CLIENT
RG GROUP / OLYMPIAN
PROJECT
The Fairfax Manchester

REV	DESCRIPTION	DATE	REV BY	CHKD
B2	Fox Screens Mark-up - Elevations

SCALE	As indicated @ A1	FIRST ISSUED	16.01.25
PROJECT	1284-21	DRAWN BY	JM
		CHECKED BY	MG
DRAWING STAGE	STAGE 4	ROLE	A
		NUMBER	00-221
		REVISION	A

Block 2 - South West Elevation - Fox Mark-up
1 : 100

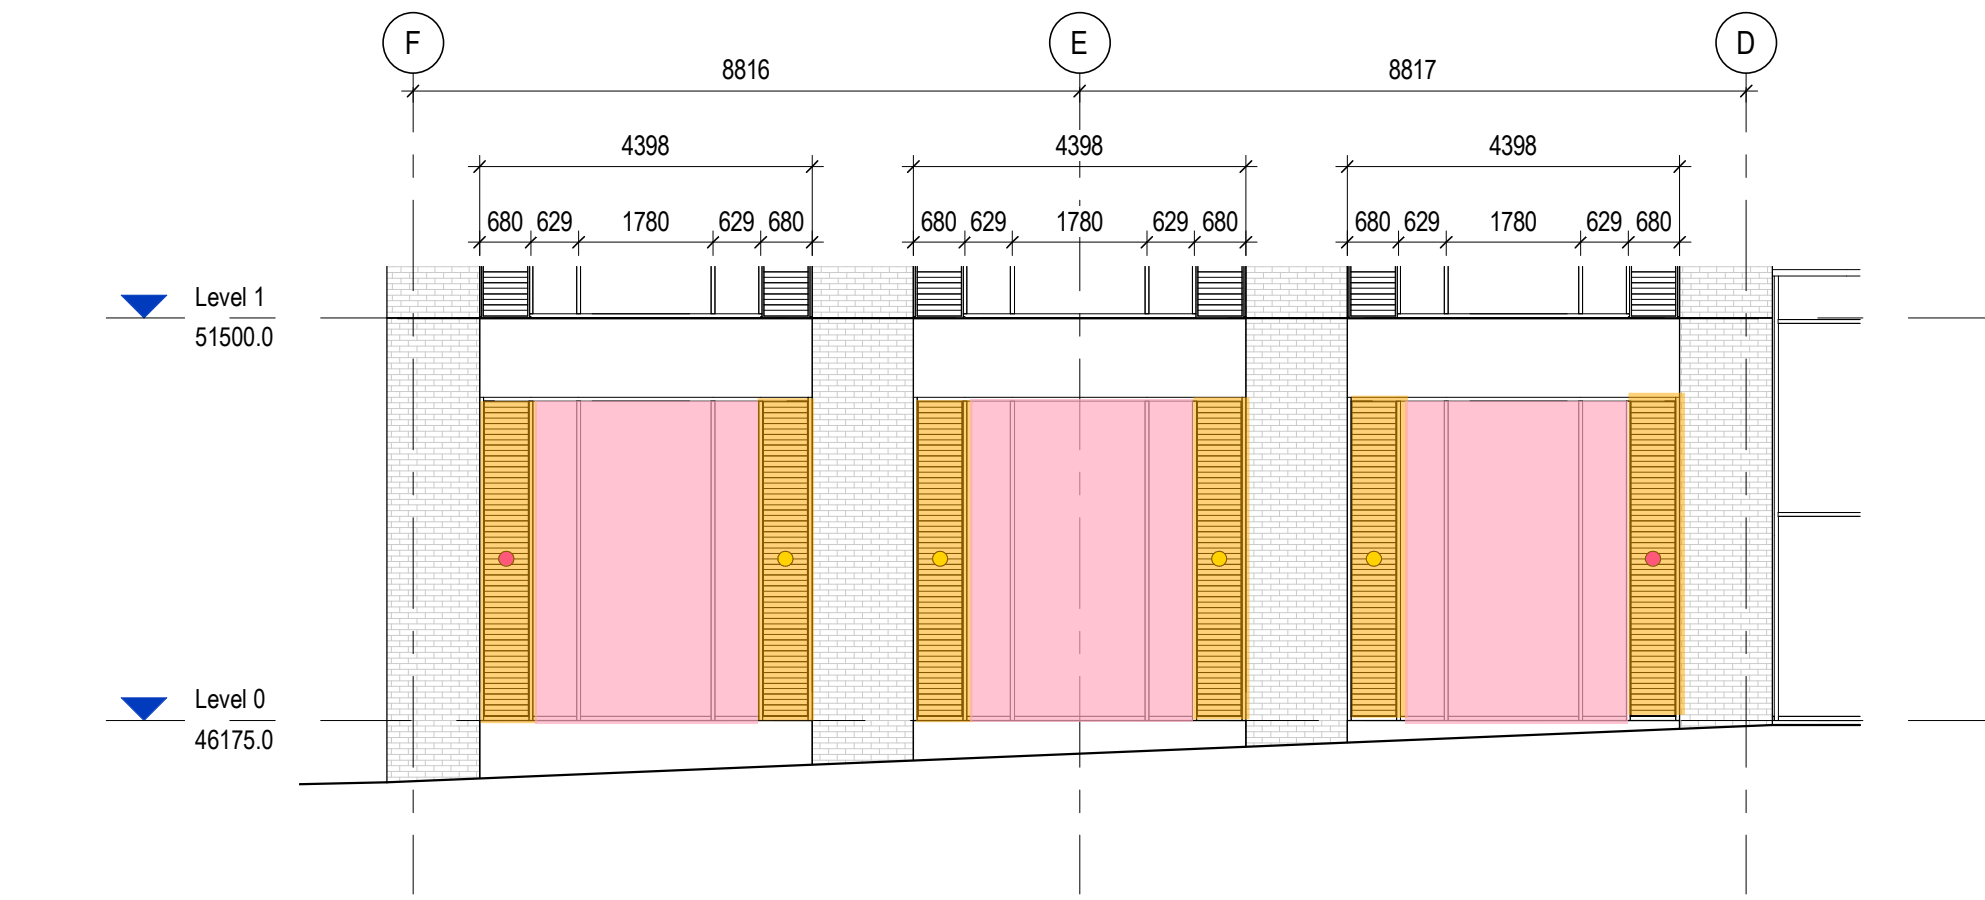
- Glazing
- Hex tray detail
- Opaque glazing
- Louvres
